Zoning Staff Report

Case Number: SP-24-007

Site Plan

NORTH CITY APARTMENTS - PHASE 2

SITE PLAN

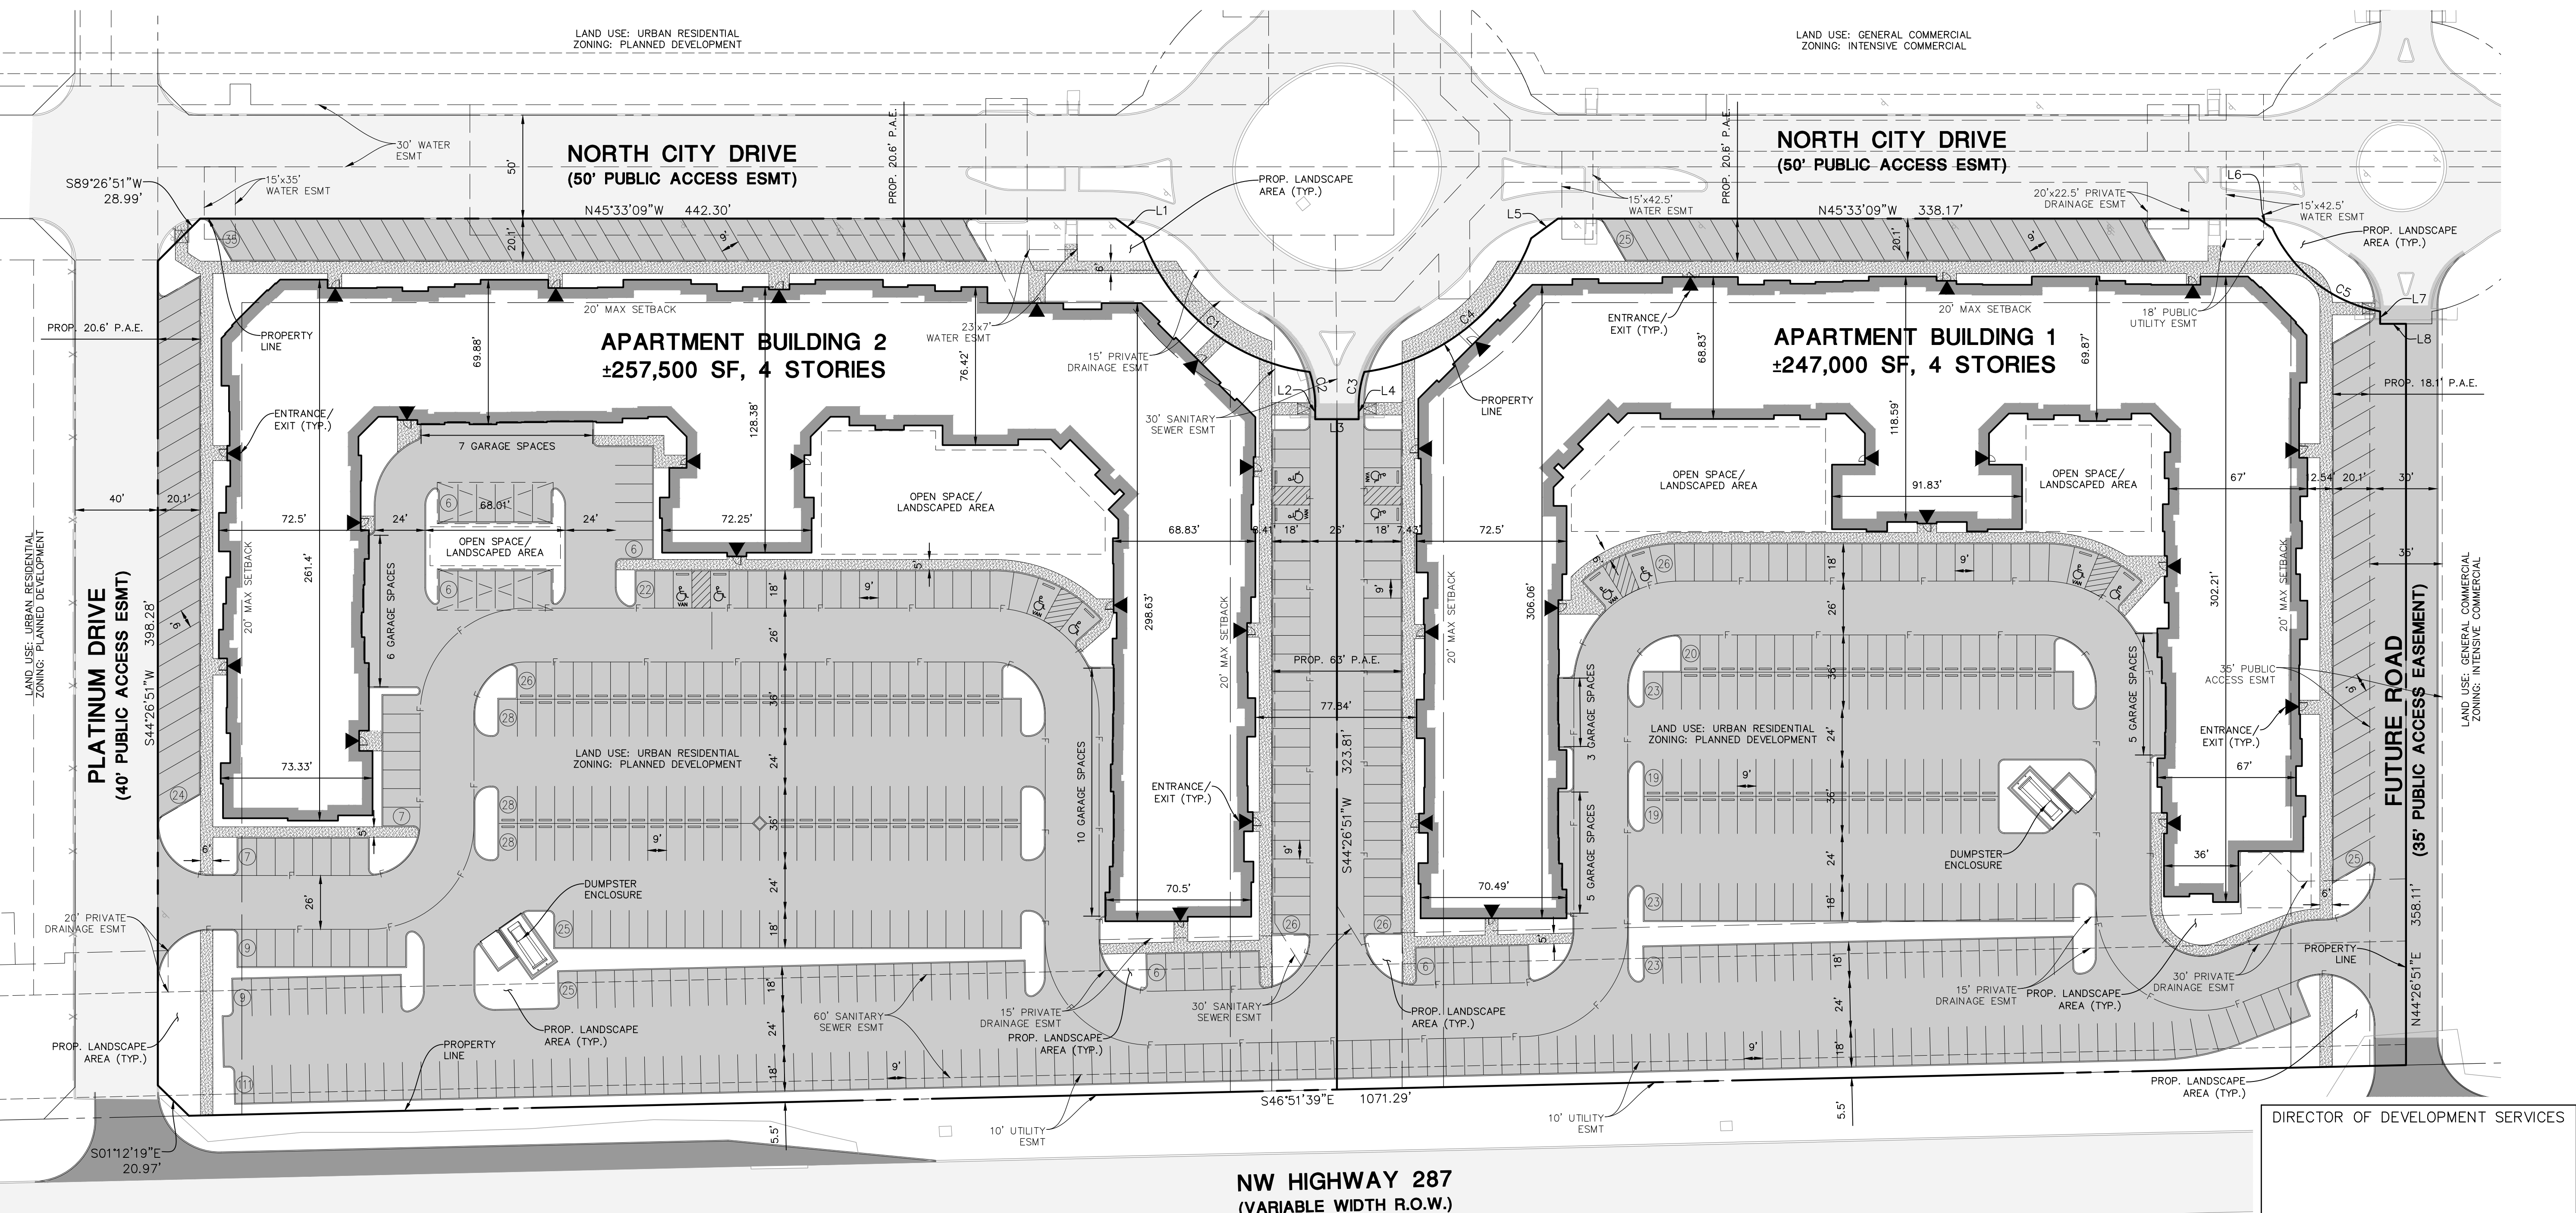
- **Setback Requirements**
 - The setbacks are exceeding the 20' max from the property line.
 - **Per PD1302-** Rear setback min can be 0' **Per Ord. 4.713.d.2-** Primary Street setback min is 0' and max is 20', side street setback min is 0' and max is 20', and common lot line is 0'.

- **Height Requirements**
 - The site plan is following the min 2 stories and the max 5 stories.
- **Parking Requirements**
 - The parking is complying.
 - **Per Ord. 4.713.e.2-** Apartments require 0.75 to 1 space required per bedroom; Plus, 2 spaces per 500 square feet of leasing office and/or social rooms. This proposed project has 705 parking spaces for 5,000 sq. ft. social rooms and 627 bedrooms but no leasing office square footage was provided. The minimum requirement for this project is 647 parking spaces.

- **Buffers, Landscaping, and Pedestrian Lighting**
 - The portion of the ordinance is not complying.
 - **Enhanced Landscaping and Pedestrian Lighting Requirements Per Ord. 4.713.f.2-** The site plan is not in compliance with this ordinance. Staff has not seen any landscape enhancements or pedestrian lighting.

- **Landscaping in Parking and Driveway Areas-** The UR district is intended to create a public environment in which pedestrian safety, interest, and comfort are paramount. Therefore, parking areas that front public streets and pedestrian pathways shall be screened to minimize pedestrians' view of parked vehicles and the impact of vehicle headlights.

- **Urban Forestry-** 5 percent (%) site canopy coverage must be provided through either preservation or planting. Developments with surface parking lots must provide 40% canopy coverage over new, expanded, or reconstructed surface parking. Submission of applicable urban forestry plans for review shall comply with Section 6.302 (g), Urban Forestry Plan/Permits.

- **Facade Variation Requirements**
 - **Facade Variation, Per Ord. 4.713.g.2-** Each new building facade that is greater than 50 feet in width and is oriented to a publicly accessible street or open space must incorporate each of the following scaling elements. For building facades less than 50 feet in width, a minimum of two elements are required. The site plan did not include elevations to show the façade variations. Staff can not determine if a waiver will be needed, but staff will need to review it before any approved site plan.

- **Building Materials, Per Ord. 4.713.g.4-** Not less than 70 percent (%) of all new building facades (not including door and window areas) facing publicly accessible streets or open space shall be constructed of the following masonry materials: stone, brick, terra cotta, patterned pre-cast concrete, cement plaster stucco, cement board siding, cast tone or prefabricated brick panels.

- **Building Entries, Per Ord. 4.713.g.5-** The intent of building entries is to create a pedestrian-oriented development in which buildings are oriented toward publicly accessible streets and sidewalks. Please follow the standards for building entries, staff was unable to review due to a lack of information shown on the site plan.
